**Proposed Public Utility Installation (Fresh Water Pumping Station) and Associated Filling of Land in Government Land at Tong Hang, Fanling (TPB REF: A/NE-LYT/842)**

**Responses to Comments Table**

<b>Comments/ Suggestions</b>		<b>Applicant/ Consultant's Responses</b>
<b>A.</b>	<b>Comments from Transport Department received from Planning Department on 07.02.2025: (Contact person: Mr. LAM To Lun, Jeffrey, Tel no.: 2399 2549)</b>

SK1 - Visibility of the Proposed Re-aligned Cycle Track at Bends

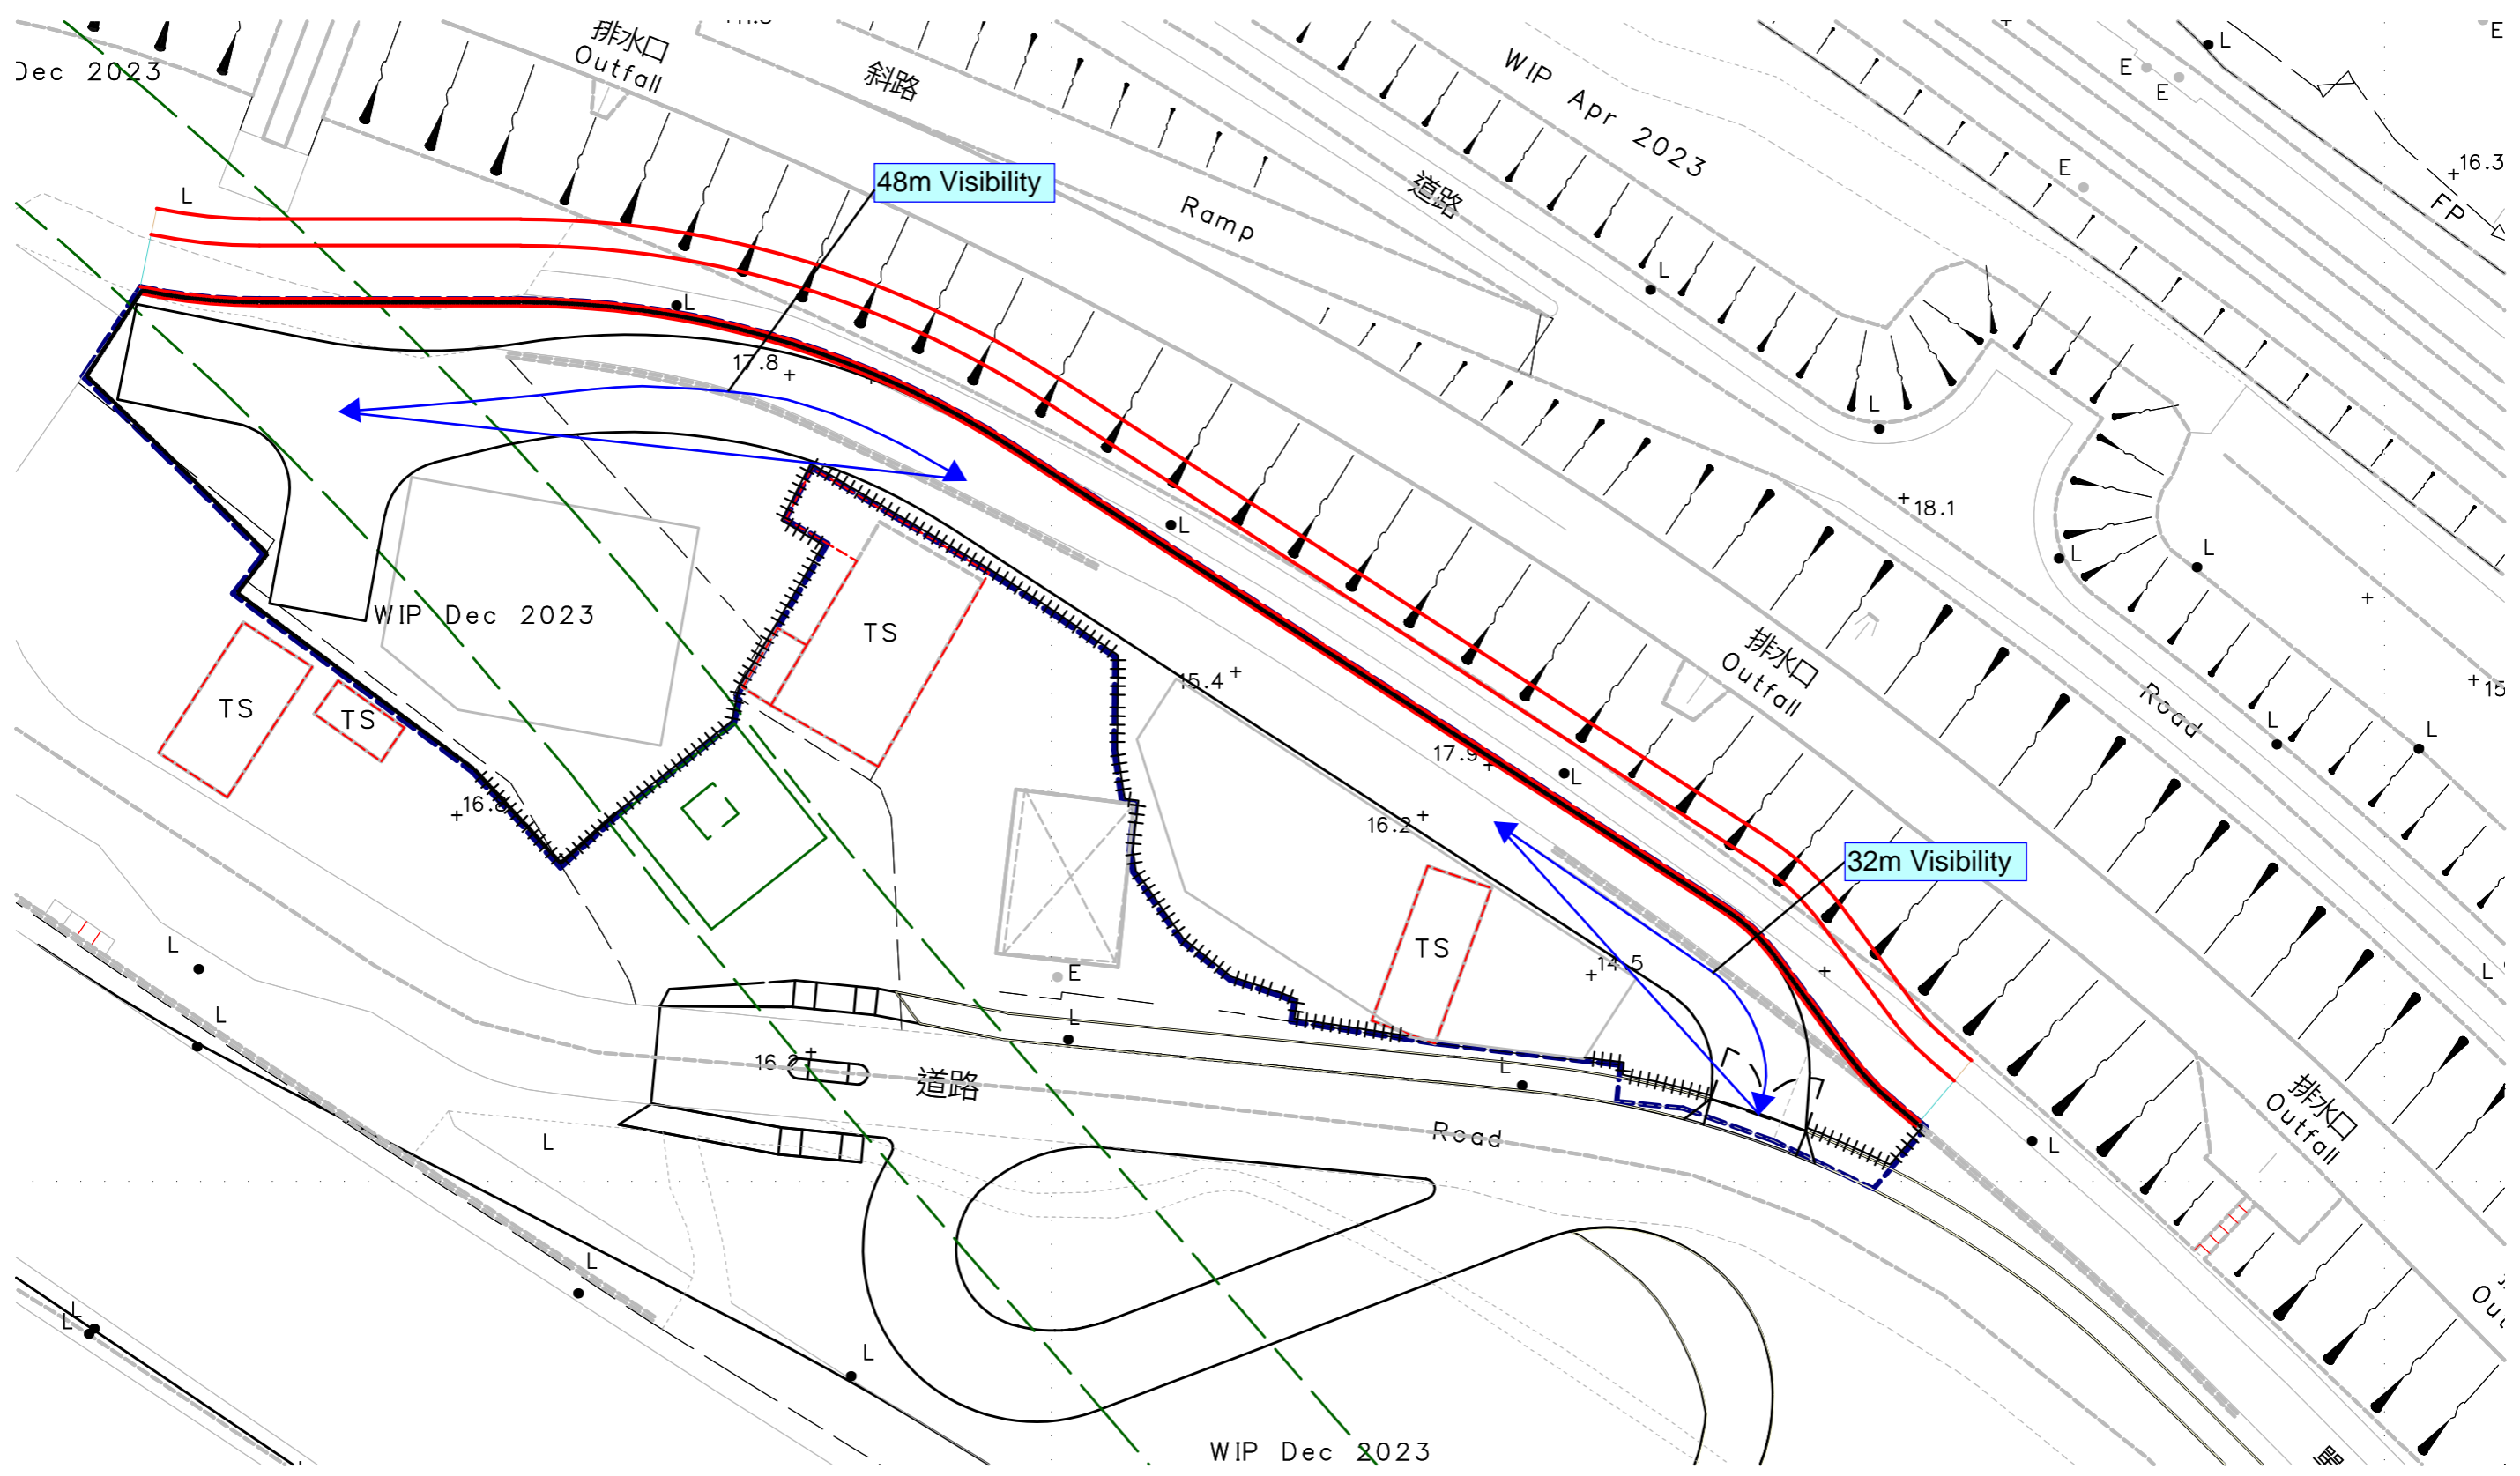
1.	Please advise the sight lines at bends on the proposed realigned cycle track, the proposed realigned footpath and the proposed internal road. Please also advise their gradients.	<p>The visibility of the proposed realigned cycle track at bends is around 17m to 23m as presented in <b>Attachment 2 – SK1</b>, which complies with TPDM's standards (i.e. minimum 15m visibility).</p> <p>For the proposed realigned footpath, taking into considerations that there is no specific sightline requirement for footpath at bends as required by TPDM and there would be no physical obstruction around the above footpath section, pedestrians would be able to see each other on footpath at bends and there shall be no sight line issue after realignment.</p> <p>The visibility of the proposed internal road at bends is around 32m to 48m as shown in <b>Attachment 2 - SK2</b>. Taking into consideration the speed limit of the internal road is around 8km/hr (i.e. much lower speed than other public roads of which the visibility requirement is 50m for 50km/hr), it is thus considered acceptable.</p> <p>The gradient of the footpath, cycle track and the internal road would be designed to comply with TPDM's standard and match with the existing / future finishes level of the surrounding during detailed design stage.</p>
